Reference: NHTSA Identification Number 04V-386

Safety Recall B37 **Upper Power Steering Return Hose**

2002-2004 (RS) Dodge Caravan/Grand Caravan, Chrysler Voyager and Town & Country

Figure 1

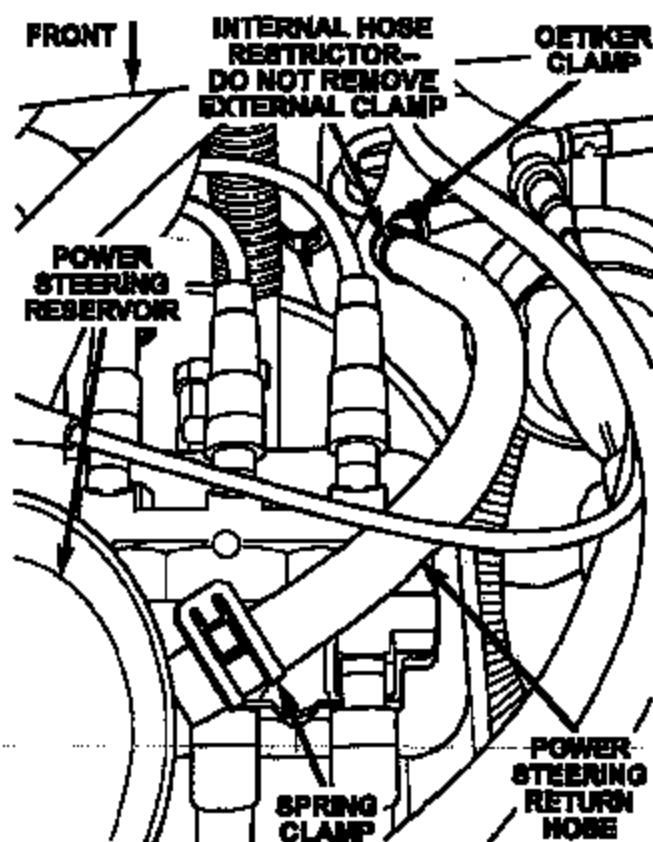
The upper power steering return hose on about 680,000 of the above vehicles may split and leak fluid. Power steering fluid leakage in the presence of an ignition source can result in an underhood fire.

1. Open the hood.
2. Remove the cap from the power steering reservoir.
3. Using a siphon pump, remove as much fluid as possible from the power steering reservoir.
4. Locate the upper power steering return hose that connects the steering gear to the reservoir (Figure 1).
5. Using hose clamp pliers, slide the hose clamp off of the reservoir end of the hose then disconnect the hose from the reservoir (Figure 1).
6. Using side cutters, remove the oetiker clamp from the other end of the hose then disconnect the hose from the tube section of the return line (Figure 1). Discard the hose and clamps.

The upper power steering return hose must be replaced.

7. Connect the supplied hose assembly to the tube section of the return line and to the reservoir (Figure 1).

IMPORTANT: The end of the hose with the two oetiker clamps should be connected to the tube section of the return line. The second oetiker clamp on the hose assembly holds an internal restrictor in place. Do NOT remove this clamp from the hose assembly.

8. Using oetiker clamp pliers (K-D No. 424 or equivalent), slide the oetiker clamp into position and tighten it securely.
9. Using hose clamp pliers, slide the spring clamp at the reservoir end of the hose into position (Figure 1).

NOTE: Be sure that the hose clamp is installed on the hose past the upset bead on the reservoir nipple.
